EAGLE MOUNTAIN
PLANNING COMMISSION MEETING

EAGLE MOUNTAIN CITY **PLANNING COMMISSION MEETING** **MARCH 12, 2024**
TITLE:	DISCUSSION - Concept Plan Regarding the Mountainland Supply Site Plan.
ITEM TYPE:	Discussion
APPLICANT:	Matthew Cook

Staff has reviewed the plans and has made the determination that the proposed elevations do not comply with the standards contained in EMMC 17.72 Commercial and Multifamily Design Standards, specifically as follows:

SITE PLAN
EAGLE MOUNTAIN, UTAH
FINAL PLAN SET
FEBRUARY 2024

OVERALL SITE PLAN

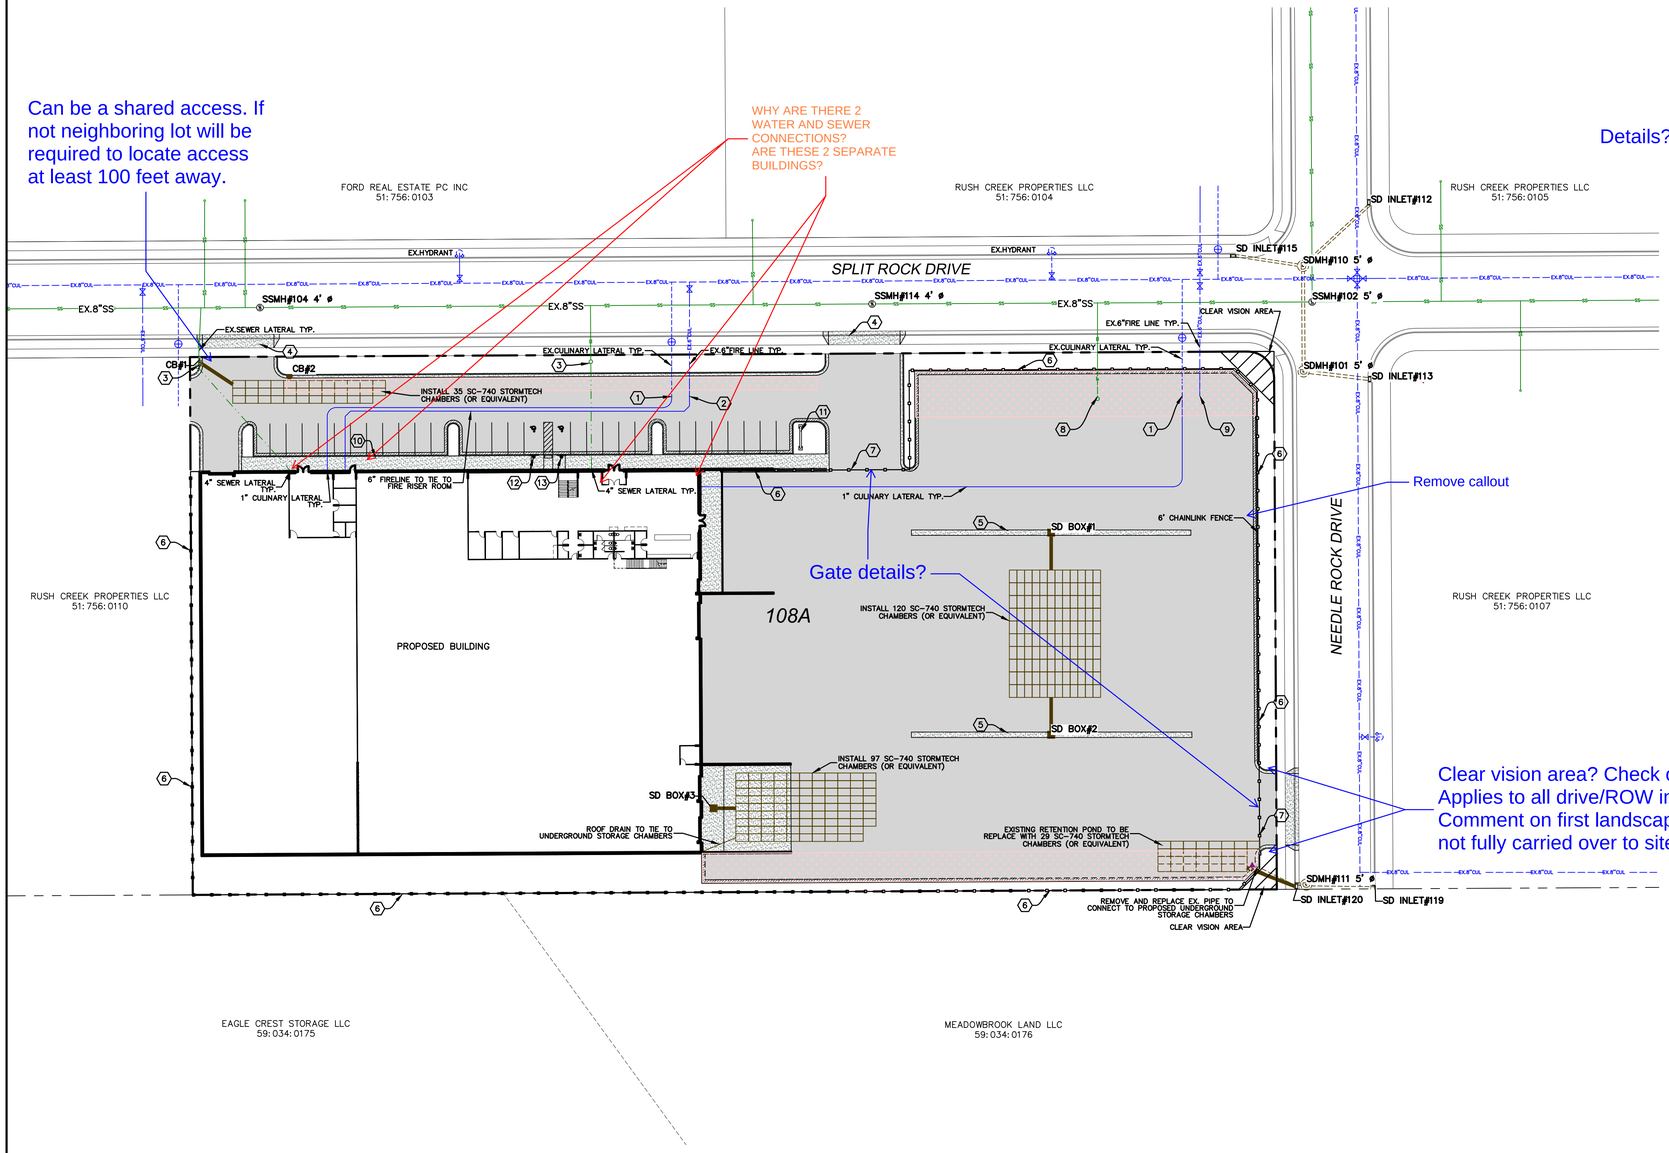
Lighting? Previous comment. No return of lighting from architect. Parking lot lighting (site) and building lighting (architecture) are typically provided together. Review EMMC 17.56. Downlight, full cutoff and night sky compliant. 100,000 lumens or less per net acre. Submit cut sheets and lumen calcs.

LANDSCAPE PLAN

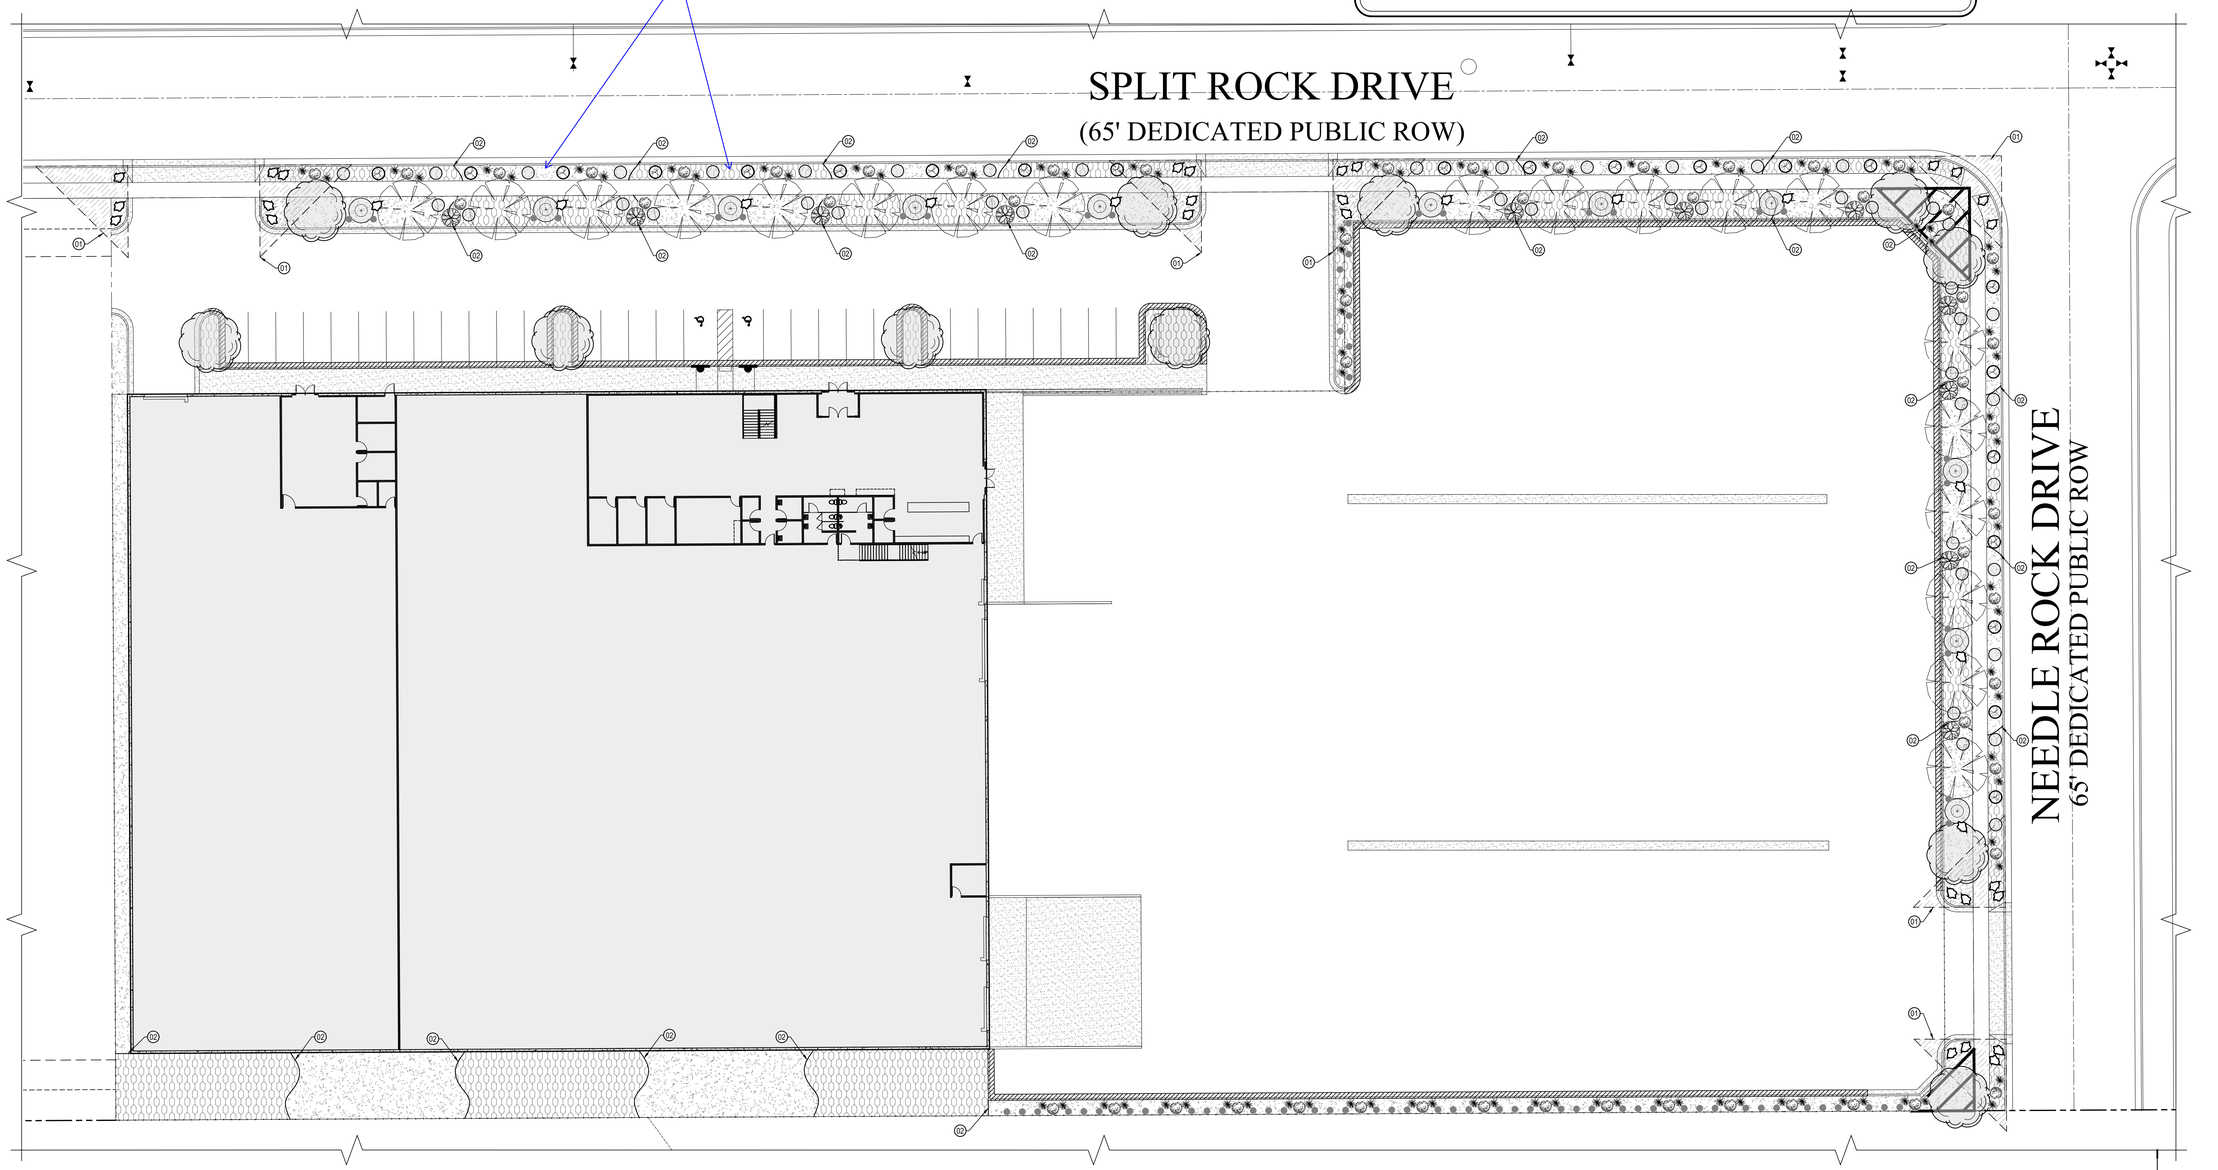
Note which plants species are drought-tolerant

Good fill-in spot (and others) for Karl Forrester grass shown on schedule but not included on-site. I think filling in these gaps along the ROW will help your case of upgraded landscaping needed when parking is in the front.

1 NORTH ELEVATION
1/8" = 1'-0"

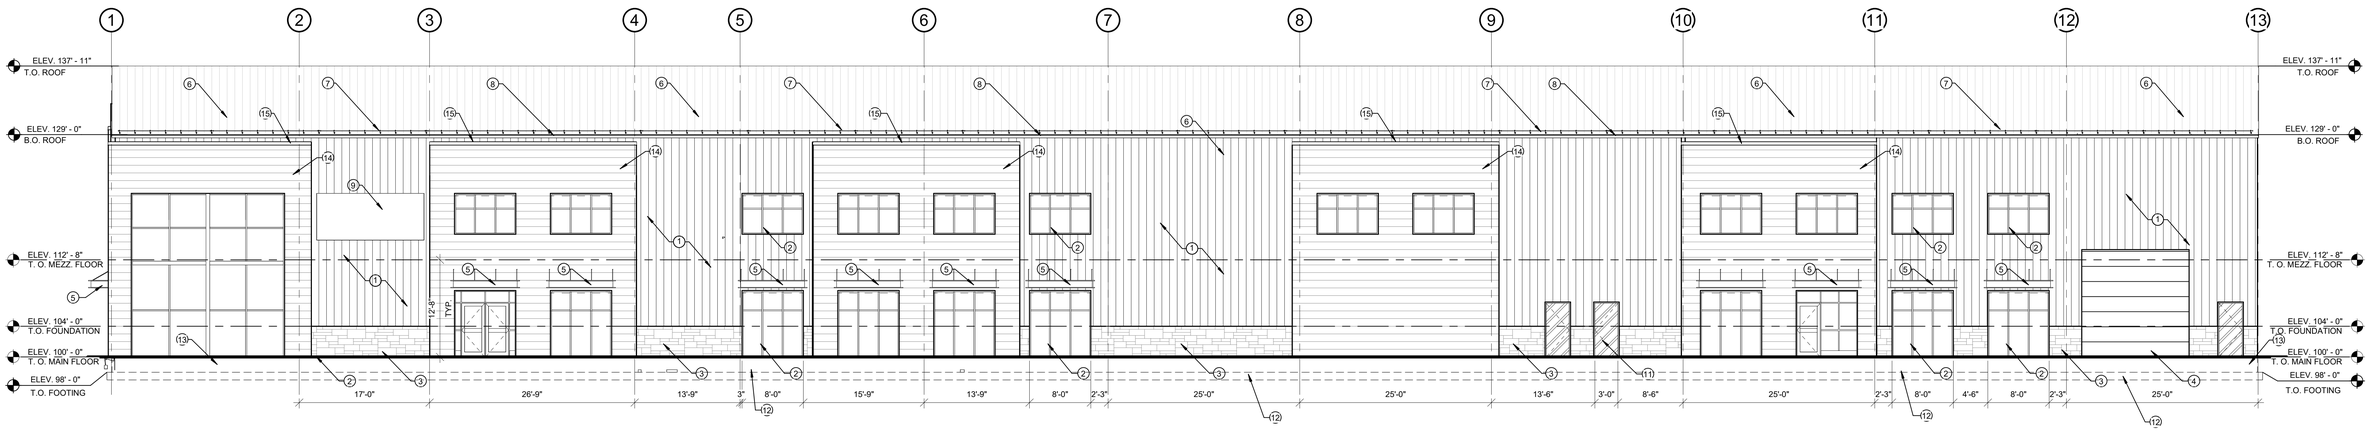
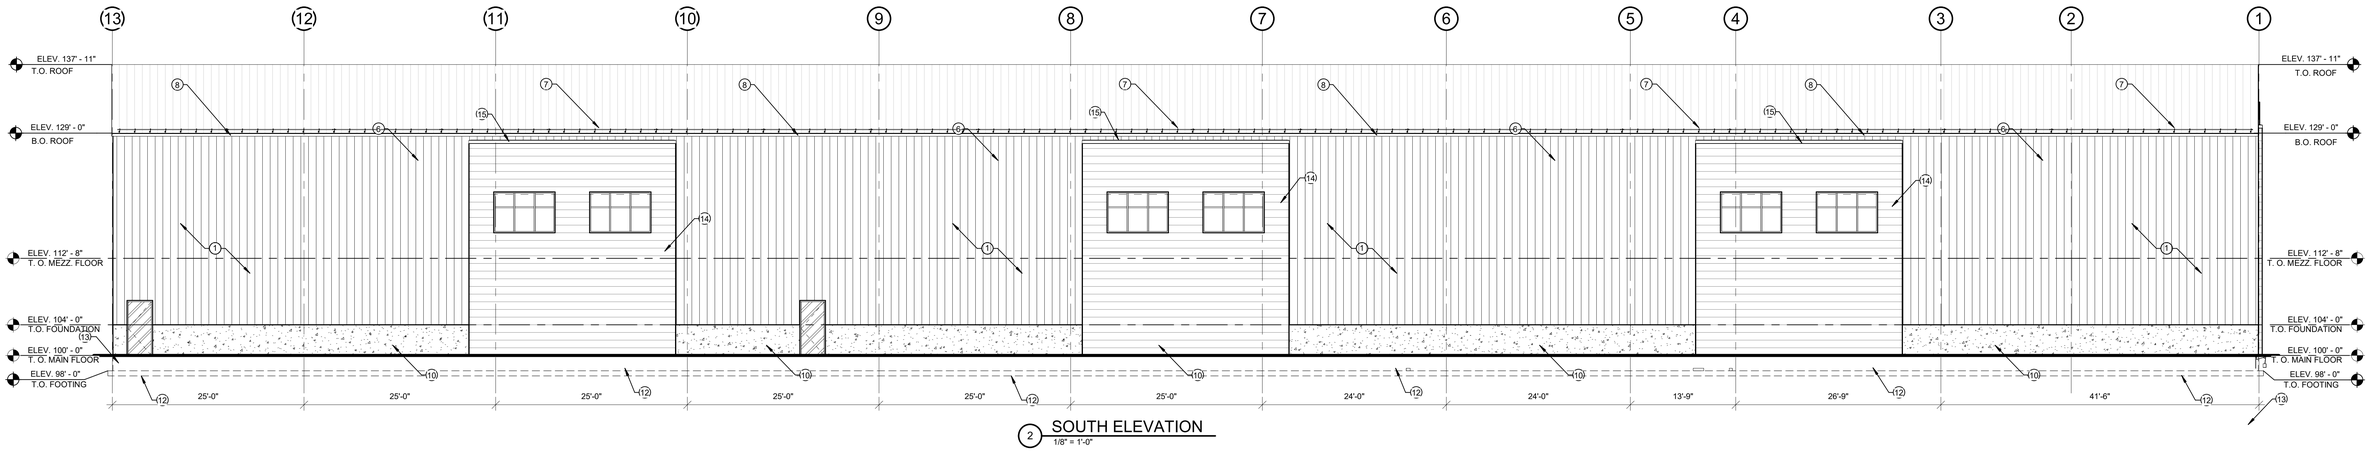
"If parking is situated between the building and the street, significant increases in landscaping, berming, and architectural features are required to break up and screen the expanse of pavement."

1 EAST ELEVATION
1/8" = 1'-0"

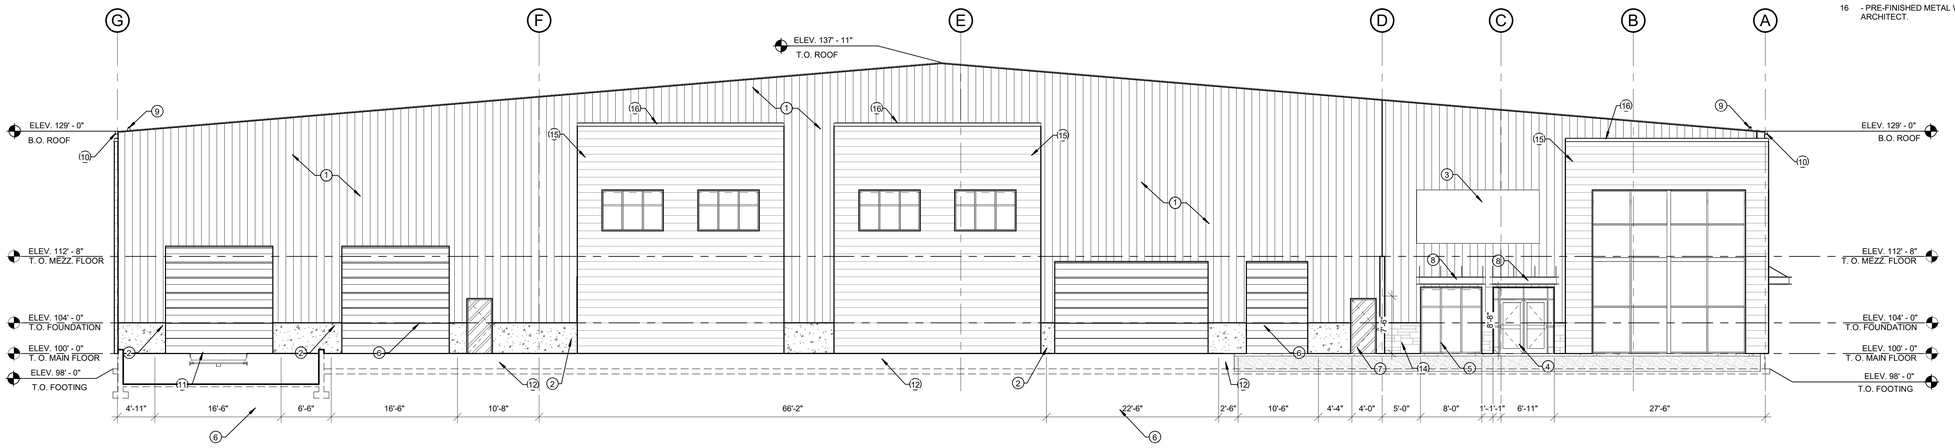
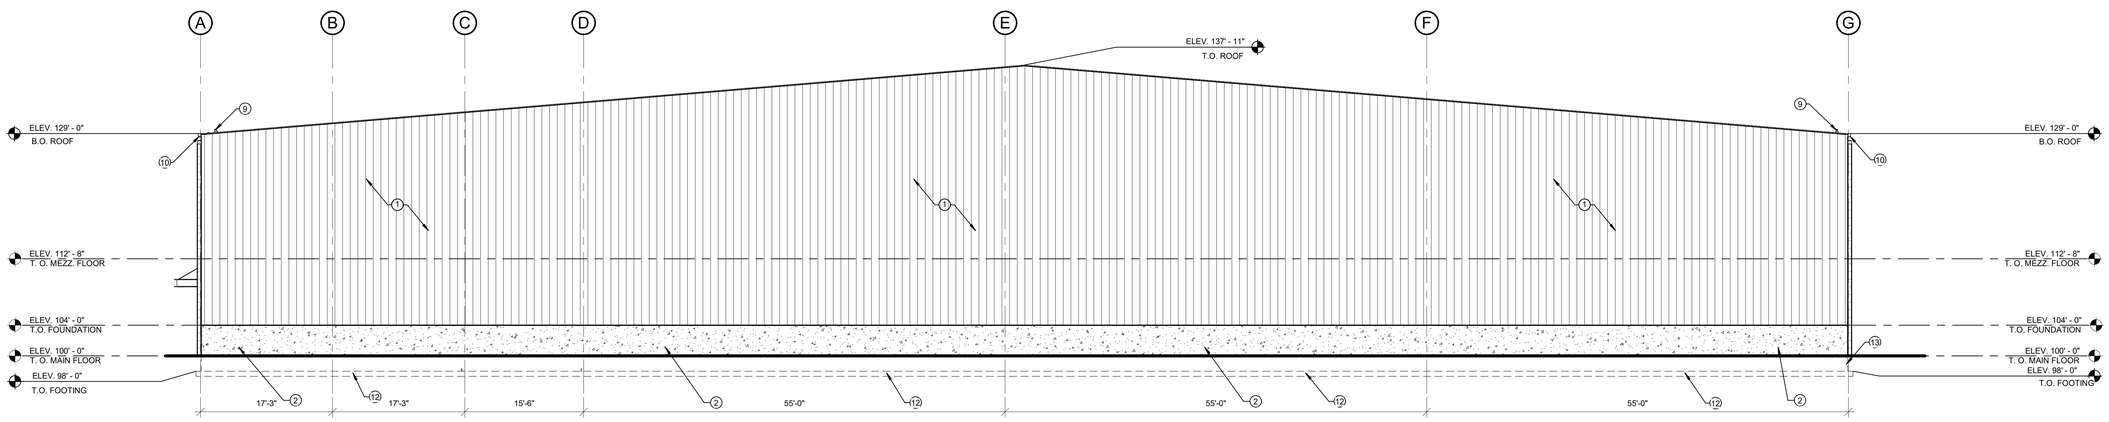
Review 17.72 (previous comments below):

"Large uninterrupted expanses of a building wall are prohibited."

"Metal, plain CMU, or other materials deemed appropriate by the planning commission and city council may be used as accents only."
